April 4, 2007

RE: West Chicago Street Lights

BLACK HILLS POWER			
SW RAPID CITY - BEN FRENCH 69KV LINE			
69KV DOUBLE CIRCUIT TANGENT			
DRAWN BY	DATE	DWG NO.	STDCDA
APPR BY	DATE	REV	0/10

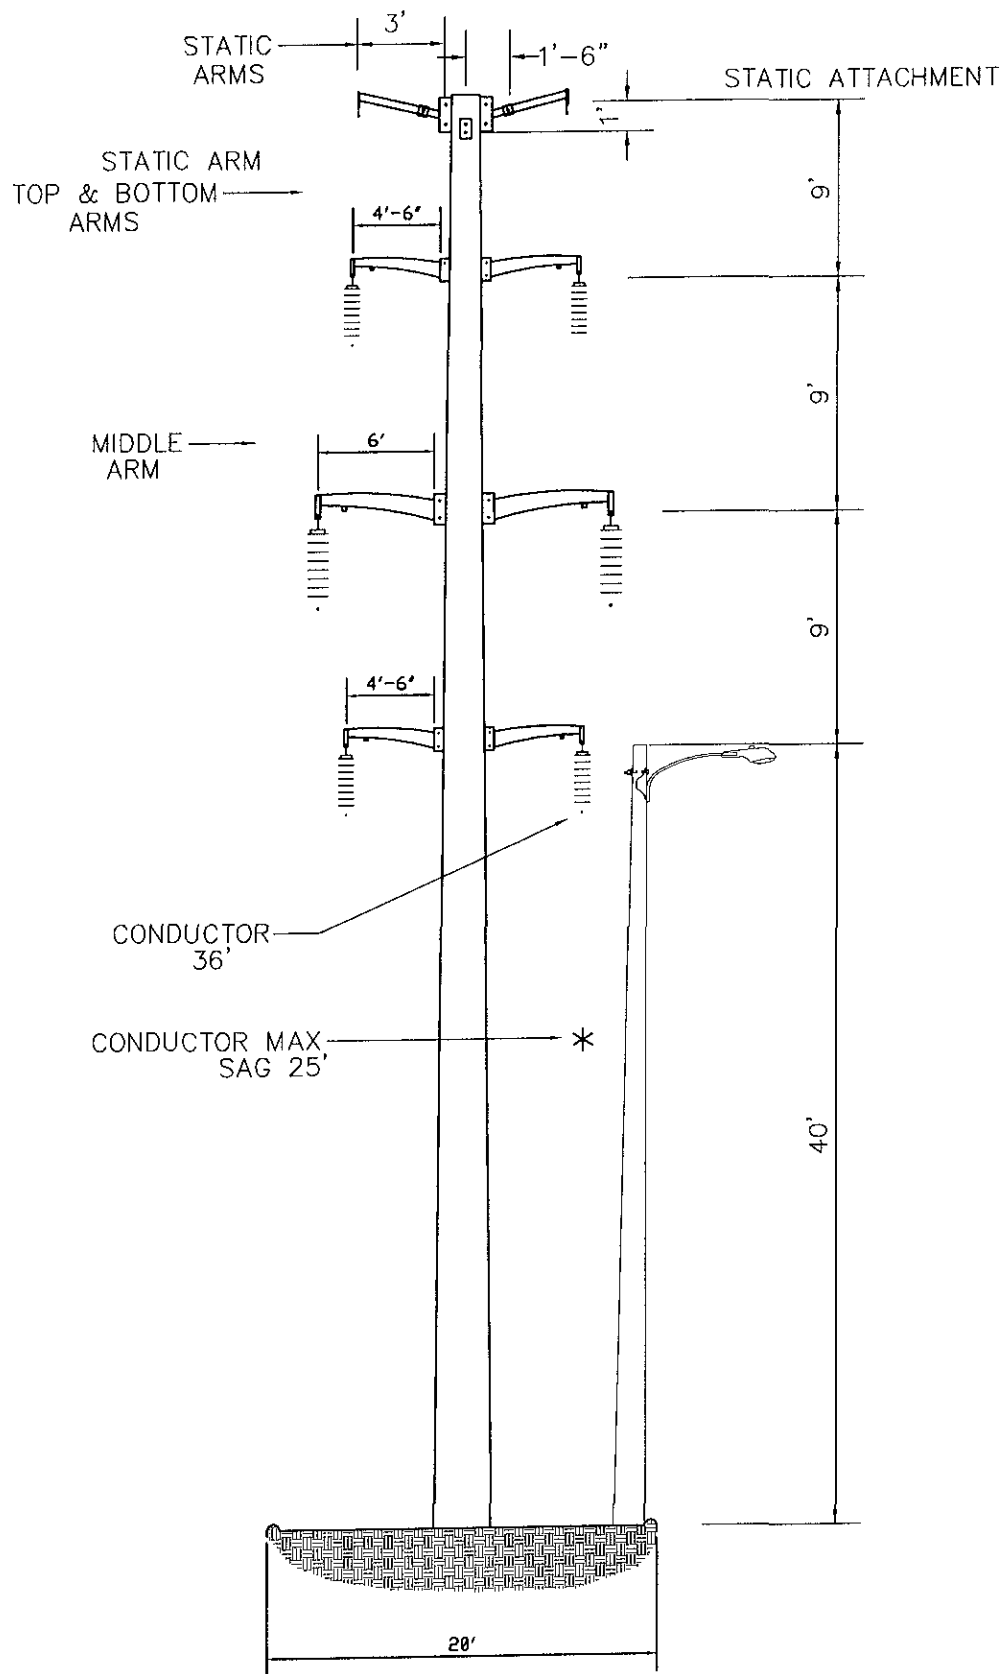
I've reviewed information you provided on the proposed street light additions to West Chicago and believe there are some issues that might affect this project. With a boulevard of 20 feet and our existing 69kV double circuit running down the center of the boulevard there is very little room for street lights. I've attached a drawing showing an average sized steel tower of 85 feet as it would fit within boundaries of the boulevard.

As you can see maximum conductor sag falls within 25 feet of the ground. NESC code clearance requires 9 feet horizontal, and 9.5 feet vertical from 69kV. I believe that the NESC and OSHA rules would be breached during digging, installation, and maintenance of any lighting structures placed within the boulevard and a safe working distance can not be maintained.

I would strongly suggest looking at other design options for lighting of West Chicago. If you have any questions please contact me.
